From: [REDACTED]
Sent: Wednesday, 8 October 2014 6:17 PM
To: [REDACTED]@newhopegroup.com.au; [REDACTED]
[REDACTED]@newhopegroup.com.au)
Cc: newaclandproject@coordinatorgeneral.qld.gov.au; [REDACTED]
[REDACTED]@coordinatorgeneral.qld.gov.au)
Subject: TRIM: Information request: issues raised in AEIS submissions; CGER requirements
Attachments: [REDACTED] aeis-submission-fact-sheet-and-form-new-acland.docx; ExpertNoise Report_New Hope Coal EIS_ARB.pdf; submission on additional EIS information; [REDACTED] New Acland AEIS - [REDACTED].pdf; FINAL Stage 3 AEIS [REDACTED] resp_280914.pdf; FW: Social Impacts -New Acland Stage 3; Submission on the New Acland Coal Mine Stage 3 project signed.docx; [REDACTED] Response to NAC Additional Information.pdf

As discussed [REDACTED] and I have reviewed AEIS submissions and request the following information be provided to inform development of the CGER:

Re: Comments on NAC's Additional Information provided in Response to Submissions on the Draft Environmental Impact Statement (EIS) — New Acland Coal Mine Stage 3 Project

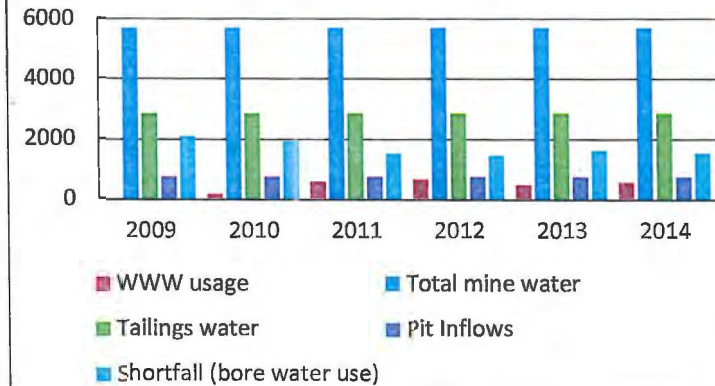
+ Intake increased significantly compared to previous month but NAC take still significantly below maximum

** NAC recycled water increased from Feb to July but minimal pumping in August

#Expect 120ML/mth from 30/1/09 to 2010/11. YTD significantly less, adjusted at 3 month review.

" NAC expected volume 150ML/mth from December 2009.

8. Monthly Wetalla Waste Water purchased (TRC OGM of Council meetings minutes)
9. Mine water usage from Table 5:17 2014 Revised Stage 3 EIS
10. Tailings recycled water used for washing (Table 5:17 Revised Stage 3 EIS)
11. Inflows from rain and bore water leakage into pit (Table 5:17 Revised Stage 3 EIS)
12. Amount of Wetalla Waste Water inferred (Total net water usage) (Total water usage – (Tailings + Inflows)).
13. Table 5:16 of EIS Mine Water Inflows. 'Deep and Shallow Groundwater Bores not considered in the mine water balance. Water balance assumes zero inputs from groundwater bores'.
14. Shortfall in water usage (ML of water) = Net water usage- WWW purchased from TRC= likely bore water consumption by NAC from GAB and/ or local bores.
